SJ PARTS SALES BULLETIN 2021

検知器・マルチモニタ用LEDランプの仕様変更 Change LED bulb lens for Detector and Multi Monitor

Product discontinuation: Auxiliary relay for SJ-H series

SJ-G Series

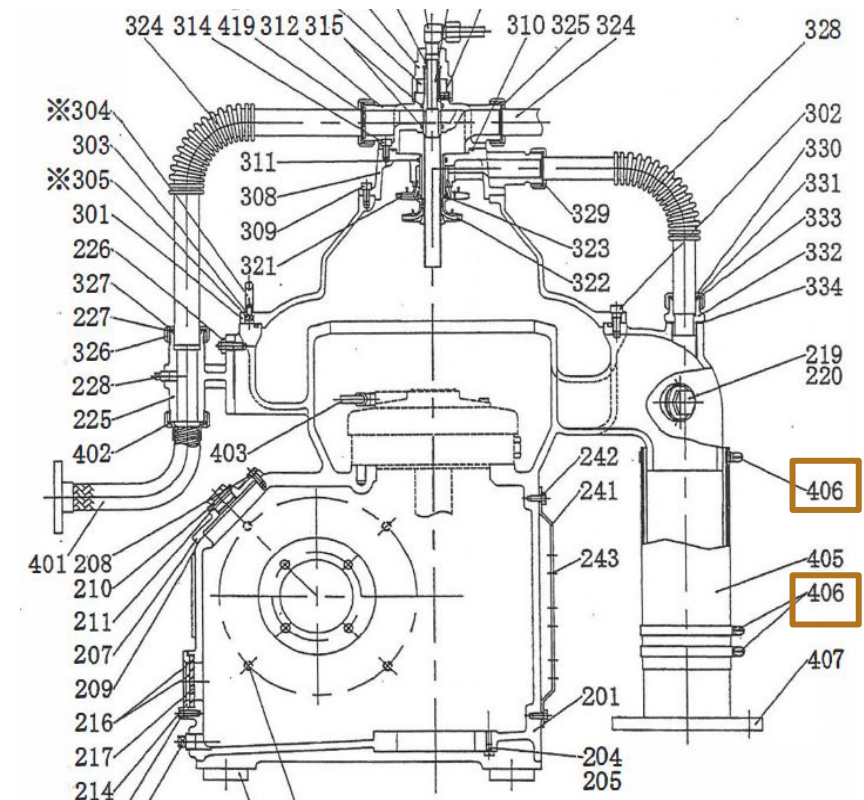
The size of hose band for SJ-F and G series will be changed. However you can use new hose band without any modification. The part number will not change.

Current model	New model
Part No.	NB0100H0	Not changed
Diameter	φ125	φ130
Screw	Slotted head	Cross head

*Relay (P/N 0DSP1A) mounted

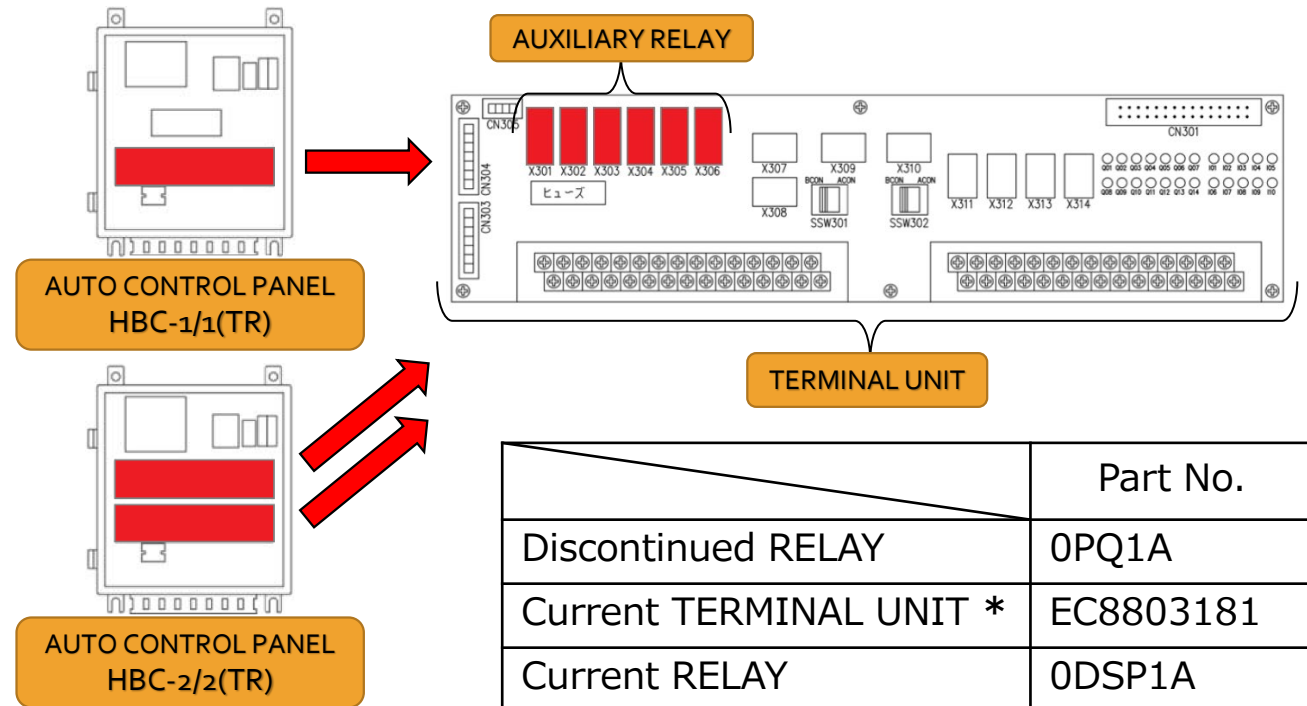
SJ-Hシリーズ用初期型自動制御盤 HBC-1/2(TR) の補助リレー PQ1a-24V が2021年9月をもちまして生産終了となります。在庫が無くなり次第、補助リレーDSP1a-DC24V仕様の現行型端子台へ交換が必要となります。

The auxiliary relay ,PQ1a-24V, used on the early automatic control panel HBC-1 / 2 (TR) for the SJ-H series will be discontinued on September 2021. If you're the user of the early control panel, and if you need the relay after the stock runs out, it will be necessary to replace your whole terminal unit with the current model terminal unit mounting the relay, DSP1a-DC24V.
